# Technical Service Bulletin

**01 MIL on, DTC P218100, P017B00, P308100, and/or P01E400 are stored in the ECM**

01 20 57 2058767/3 April 10, 2020. Supersedes Technical Service Bulletin Group 01 number 20-52 dated March 26, 2020 for reasons listed below.

*Figure 1. Gap between chamber and seal.*

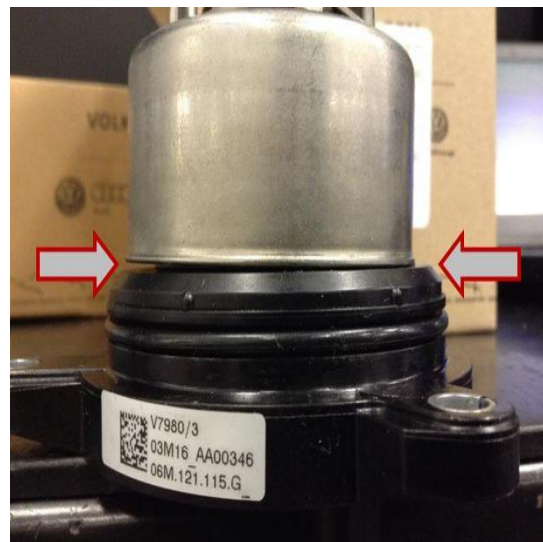
1. Remove the thermostat and check whether it closes completely. If the coolant is still warm, put the thermostat in cold water to restore its original condition. If there is a gap between chamber and seal, the thermostat is faulty and needs to be replaced.
2. Attach photos to the repair order which clearly shows that the thermostat does not close neatly.

After the repair, fill with G12evo coolant in the coolant circuit.
